**RE: Request to Amend an Order of Conditions, 20 Broad Cove Road, Hingham,
DEP File #034-1477**

PROPOSED SITE IMPROVEMENTS & MAINTENANCE ACTIVITIES
 20 BROAD COVE ROAD
 HINGHAM, MA 02043
 OCEANSIDE BUILDERS, INC.
 C/O DOUGLAS KARO
 22 WOMPATUCK ROAD
 HINGHAM, MA 02043
 Project: PROPOSED SITE IMPROVEMENTS & MAINTENANCE ACTIVITIES
 Client: OCEANSIDE BUILDERS, INC.
 Drawing Title: SITE PLAN

PROPOSED SITE IMPROVEMENTS & MAINTENANCE ACTIVITIES
 20 BROAD COVE ROAD
 HINGHAM, MA 02043
 OCEANSIDE BUILDERS, INC.
 C/O DOUGLAS KARO
 22 WOMPATUCK ROAD
 HINGHAM, MA 02043
 drawing title: GRADING PLAN

PROJECT: PROPOSED SITE IMPROVEMENTS & MAINTENANCE ACTIVITIES
 20 BROAD COVE ROAD
 HINGHAM, MA 02043
CLIENT: OCEANSIDE BUILDERS, INC.
 C/O DOUGLAS KARO
 22 WOMPATUCK ROAD
 HINGHAM, MA 02043
DRAWING TITLE: UTILITY PLAN

Scale: 1" = 30'
 Date: MAY 2, 2024
 Drawn: JAC
 Checked: ABT
 Approved: JAC
 Drawing Number: SP-1

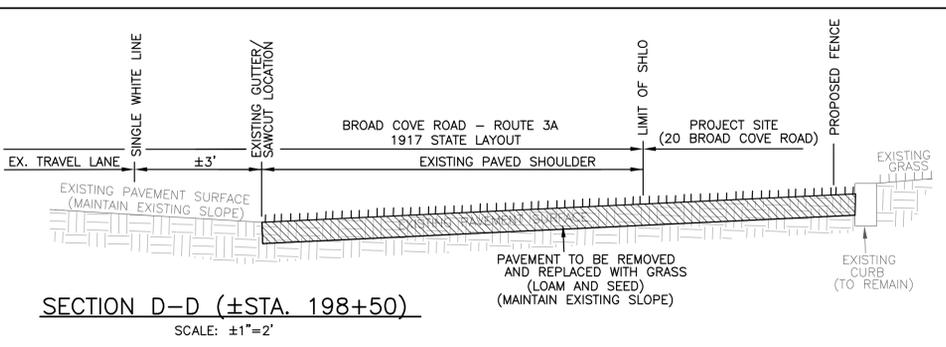
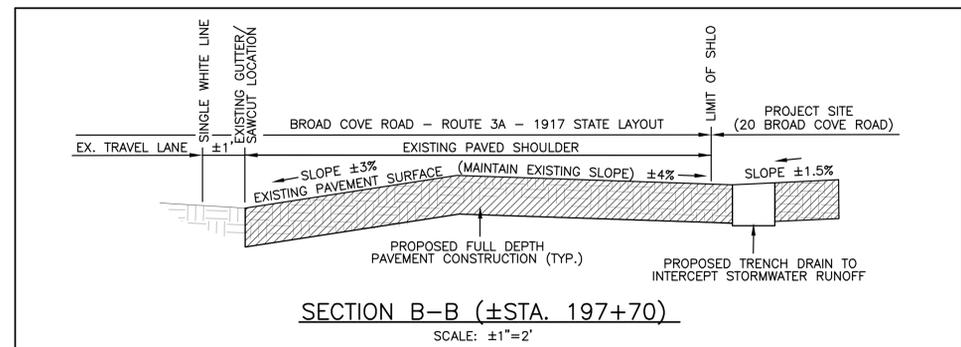
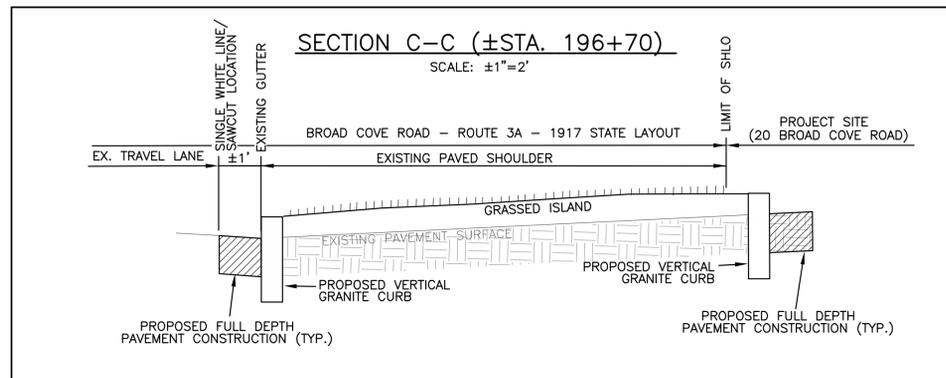
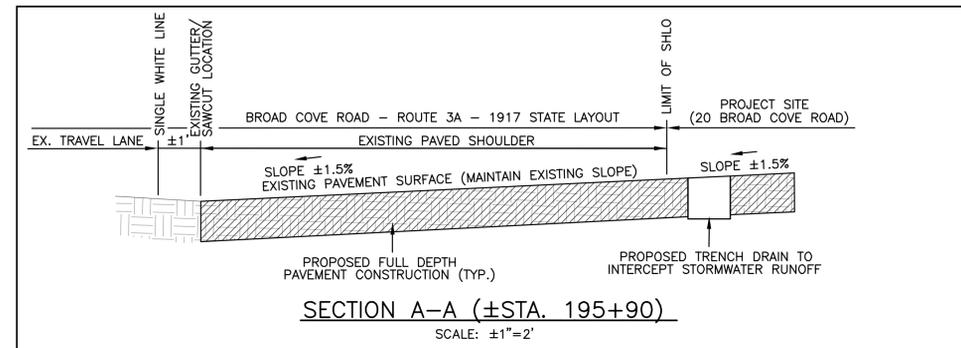
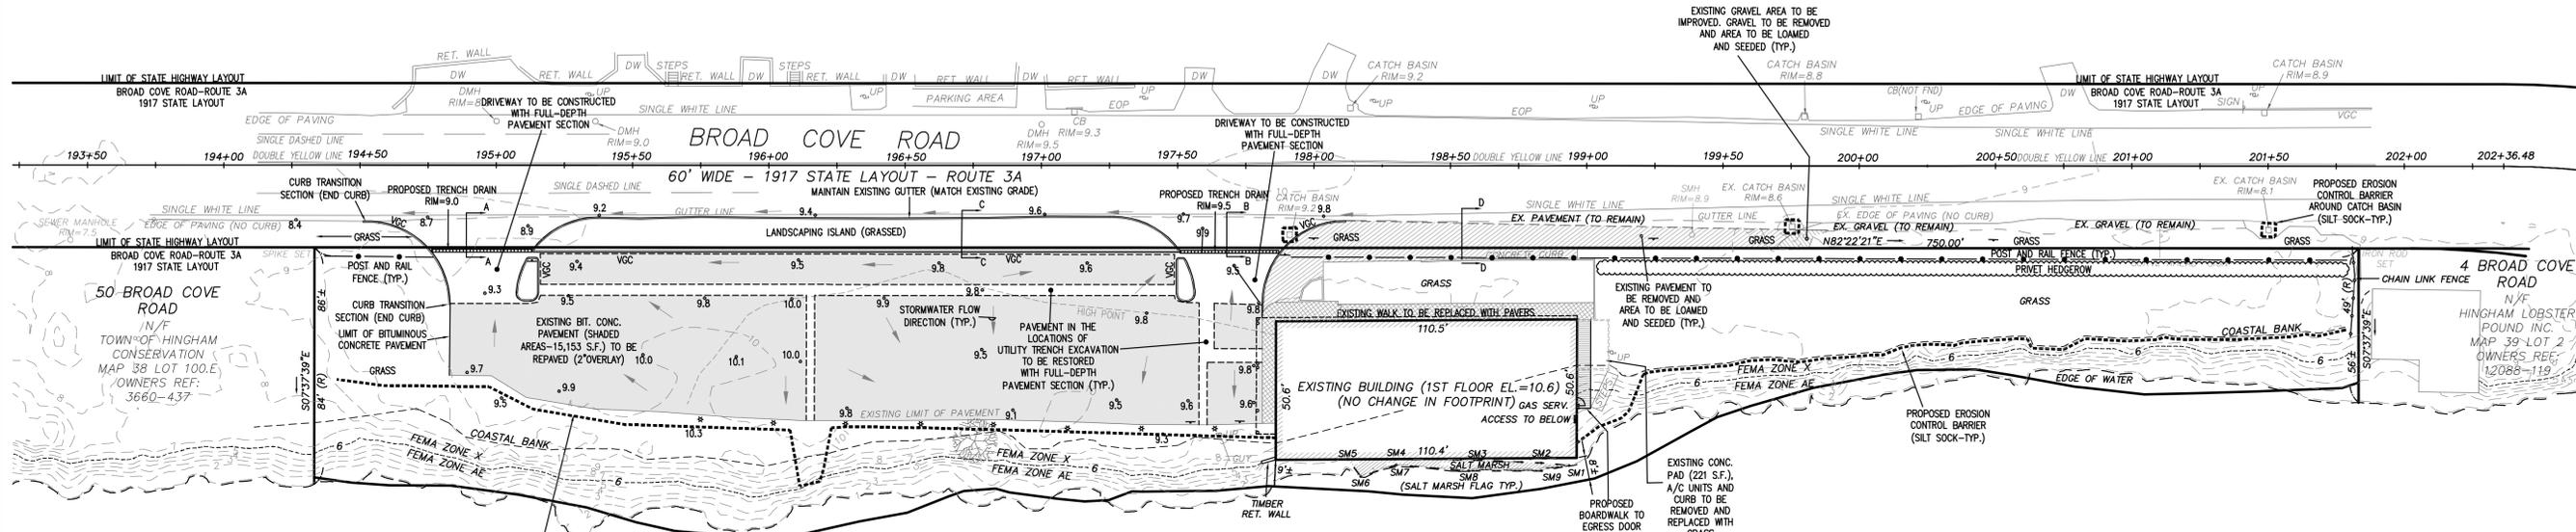
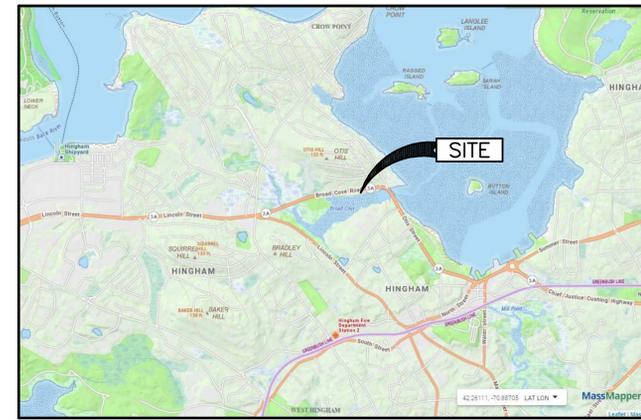
- New driveways defined with vertical granite curb and 30-foot radii are now proposed on either side of the paved parking lot. Curbing is proposed along the Broad Cove Road eastbound lane and along the northerly row of parking spaces, creating a grassed island between the curbing;

- The pavement strip within the highway layout (shoulder) and on the site property in front of the building and to the east of the building is to be converted to grass.

- The gravel strip within the highway layout (shoulder) is to be converted to grass.
- A small area of pavement on the westerly side of the parking lot is to be converted to grass;

- A traditional post and rail fence is proposed to the west of the parking lot, in front of the building and to the east of the building that will run parallel to the front property line;

- A privet hedgerow is proposed on the southerly side of the fence on the easterly side of the building;
- Three (3) "No Parking Any Time" signs are proposed in front of and to the east of the building along the Broad Cove Road eastbound lane;

Scale:	1" = 30'
Date:	JULY 11, 2024
Drawn:	JAC
Checked:	ABT
Approved:	JAC
Drawing Number:	UP-1

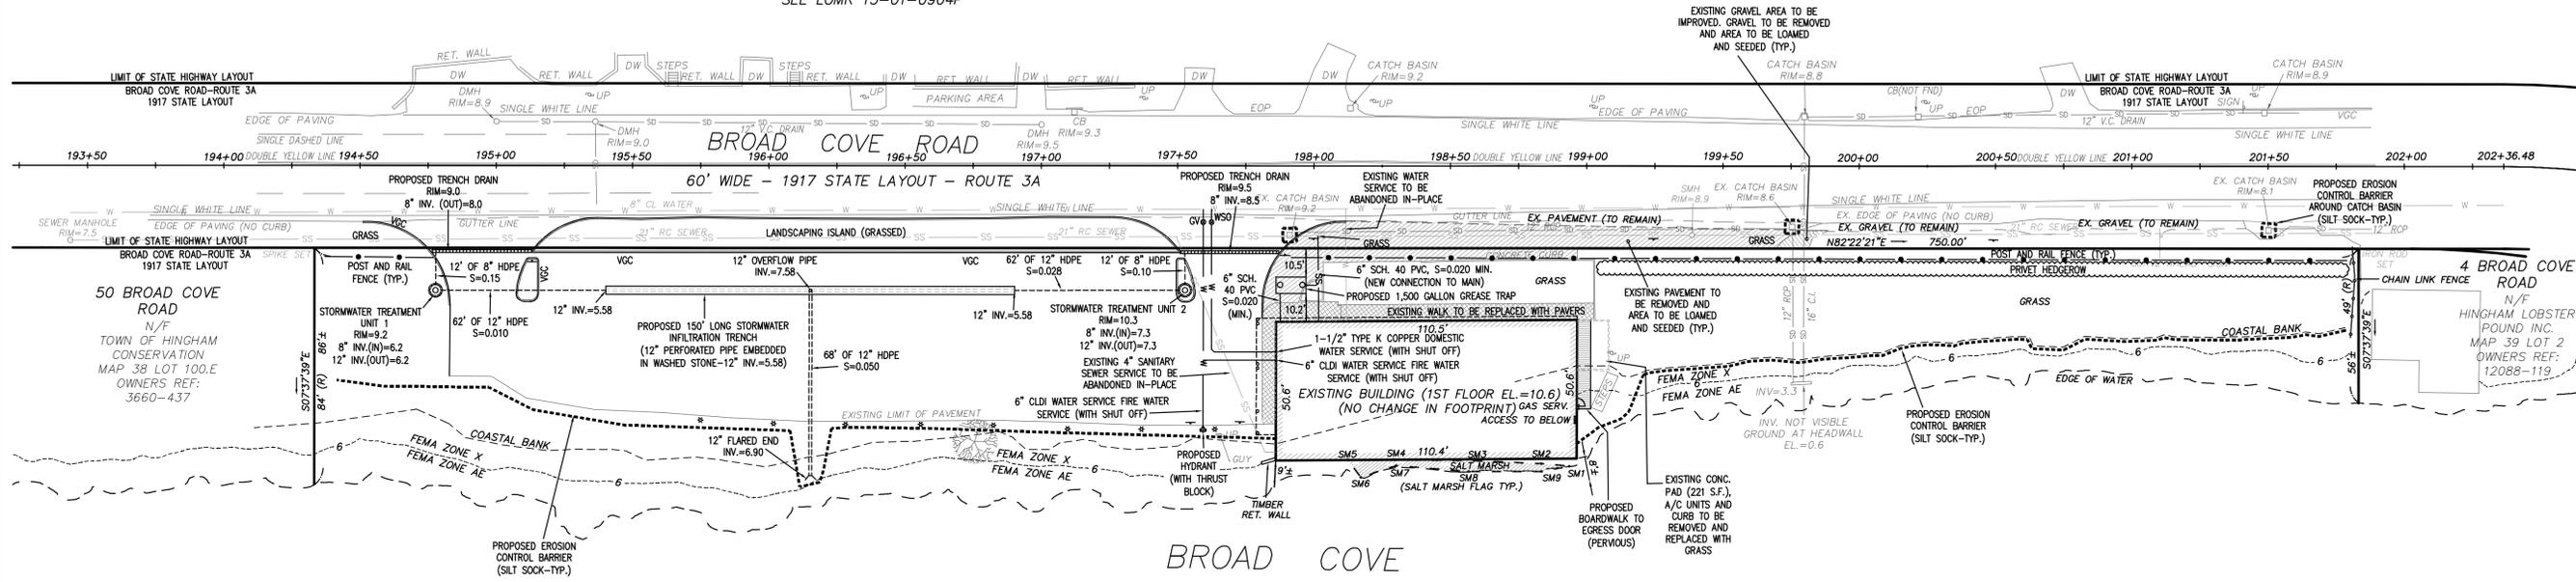
- The Utility Plan presents a stormwater management system that consists of trench drains, stormwater treatment units and a subsurface infiltration trench. The system has been designed to intercept stormwater runoff currently flowing onto Broad Cove Road and infiltrate it into the ground.

- Installation of a grease trap is proposed to be connected to the existing sewer system servicing the site. The grease trap is a contained system (no leach field) and is located no closer than the existing sewer lines currently in place at the site;

- Installation of a new fire hydrant and water main line are now proposed;
- Proposed boardwalk to egress door along the east side of the building;
- Removal of the previously approved 1,348 square foot non-pervious patio to the east of the building. This footprint is proposed to be seeded as grass to match the surrounding area;
- The approved overhang at the north and west side of the building has been reduced to only the west side of the building. The revised overhang is within the footprint of the previously approved overhang;
- Proposed lamp lighting along the south side of the parking lot to include eight lamps located just off the existing pavement.
